FIRST MARKET BANK

SPECTRUM DESIGN PROJECT NO. 06126

GRADING & DRAINAGE PLAN

C-1.3

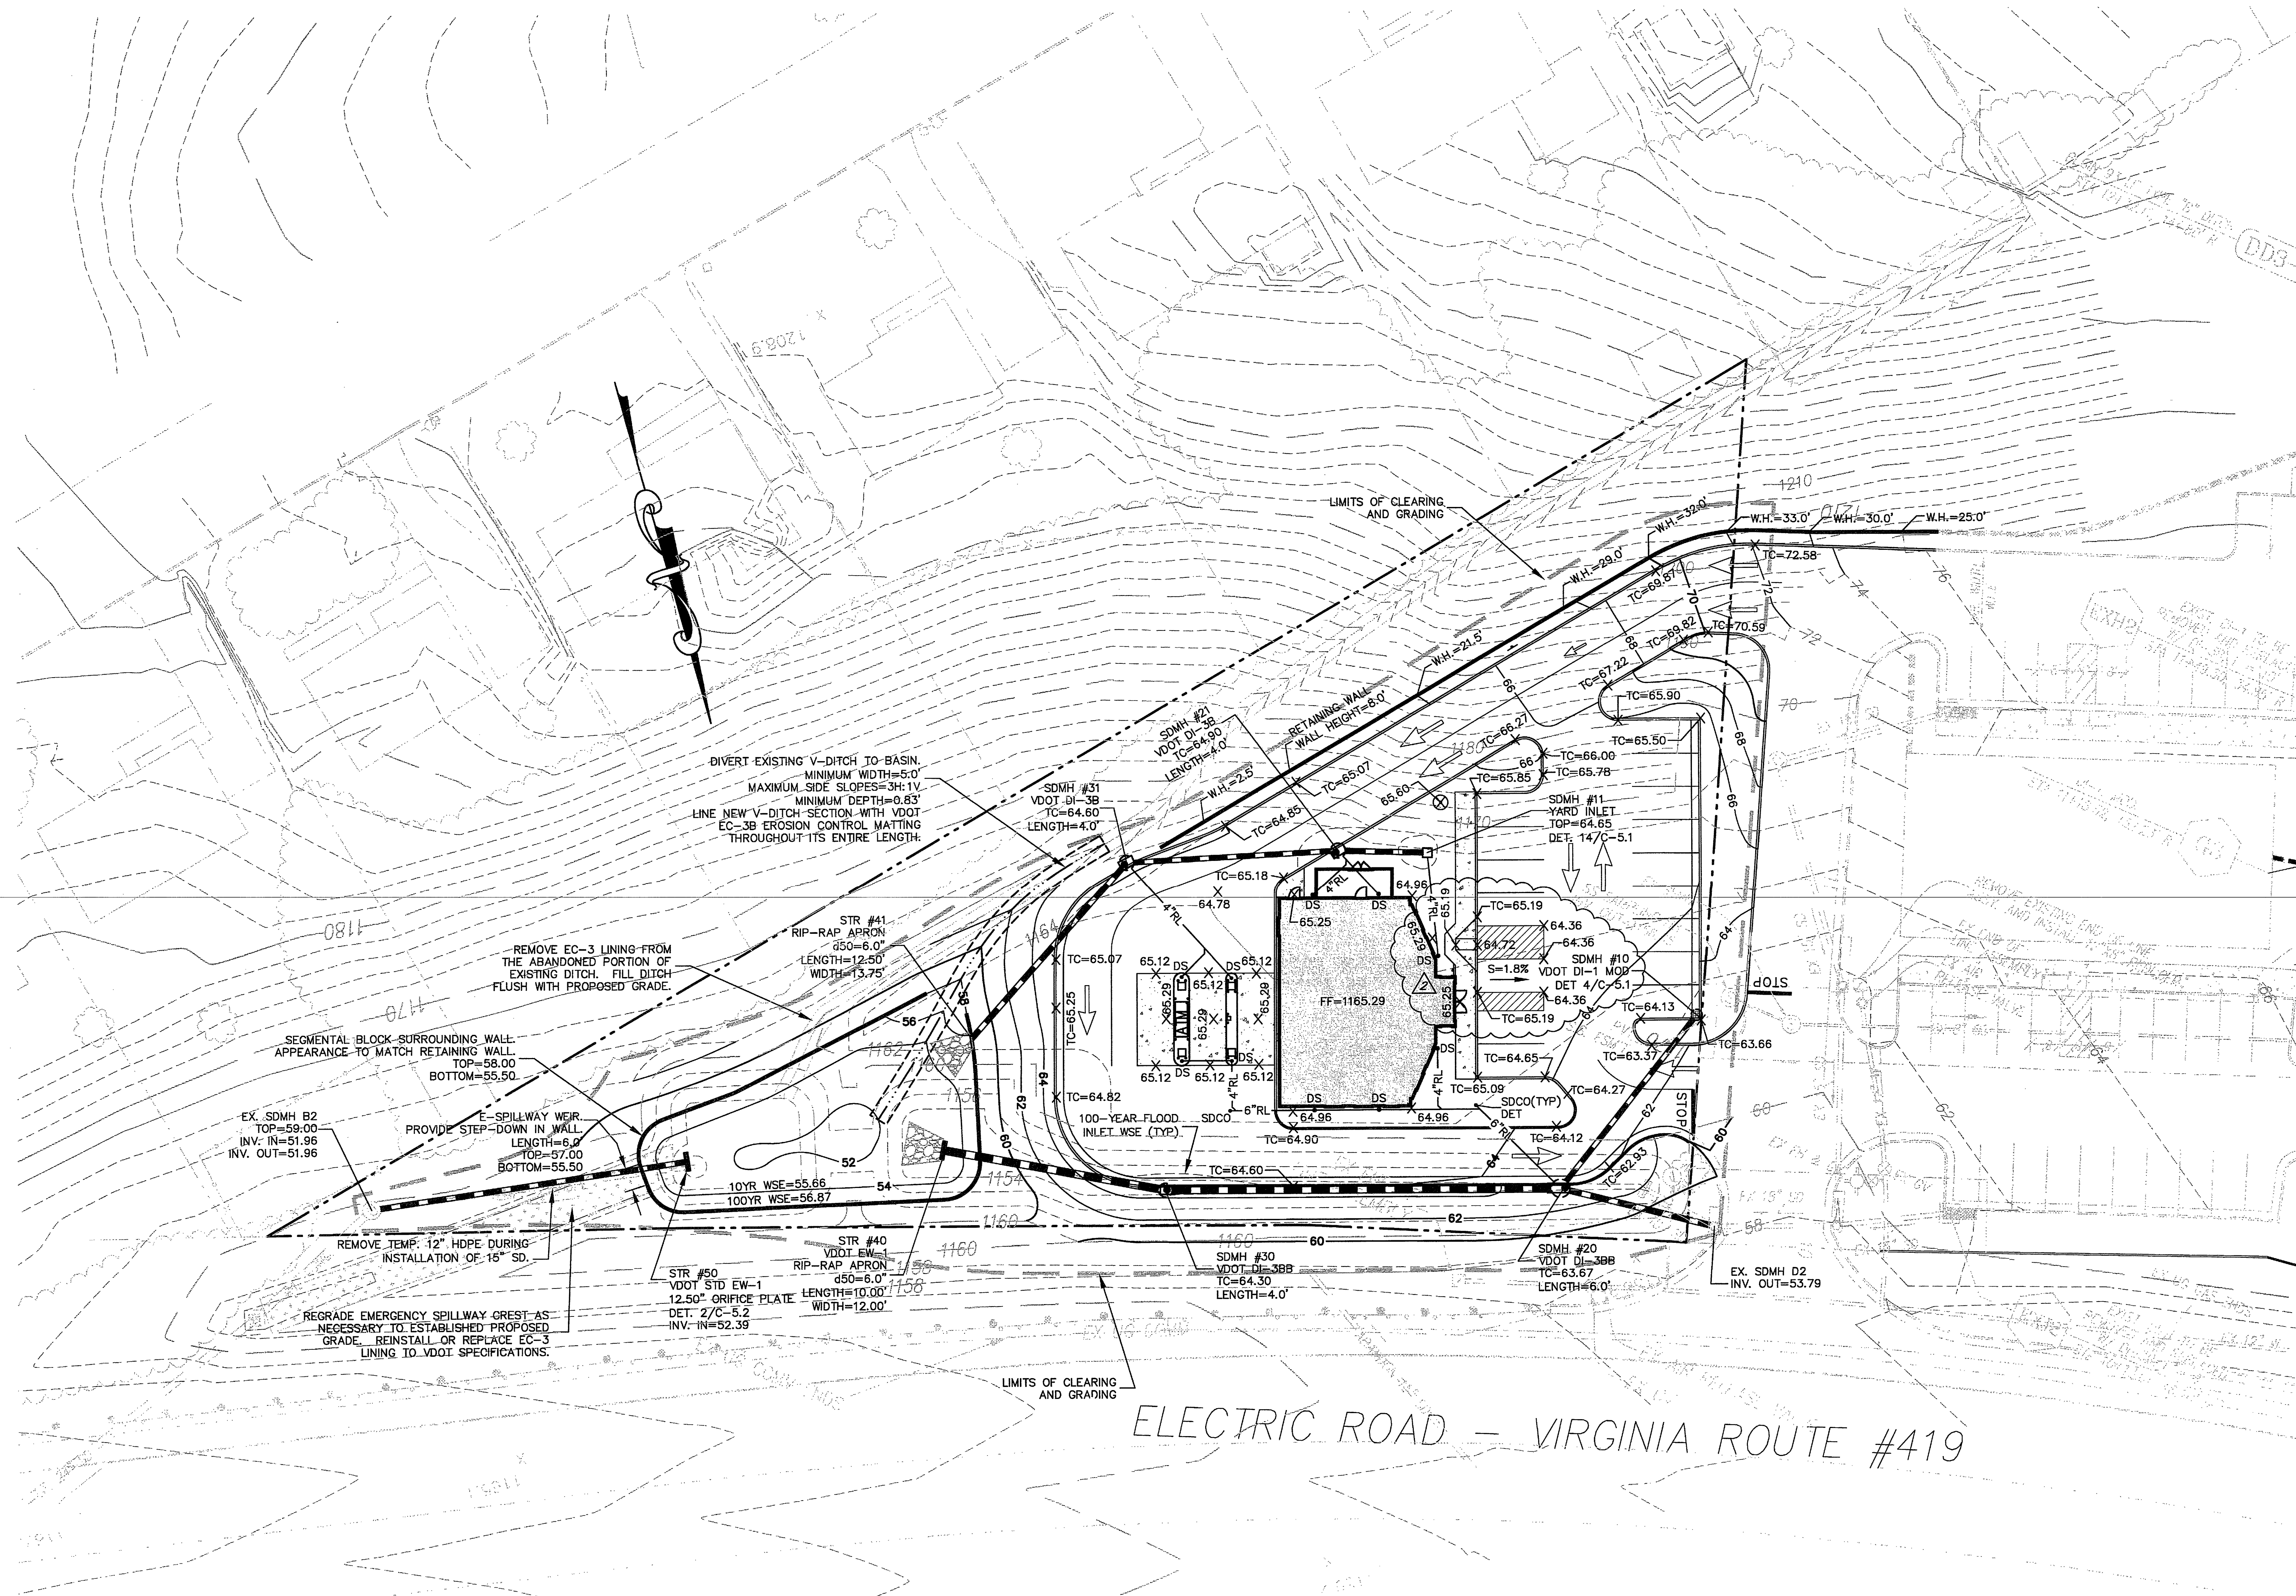
- REVISION NOTES:
1. REQUIRED INLET LENGTHS FOR STRUCTURES 21,30,31 MODIFIED.
 2. SEGMENTAL BLOCK BASIN SURROUND ADDED (2.5' MAXIMUM HEIGHT).
 3. GRADING AROUND FRONT ENTRANCE OF BUILDING AND HANDICAPPED PARKING SPACE MODIFIED.
 4. DI-1 INLET STRUCTURE AT BASIN WAS REMOVED. BASIN ORIFICE PLATE MODIFIED.
 5. RIP-RAP REMOVED FROM DITCH TO BASIN, VDOT EC-3B ADDED.
 6. RIP-RAP OUTLET PROTECTION DIMENSIONS AT STRUCTURES 40,41 CLARIFIED.
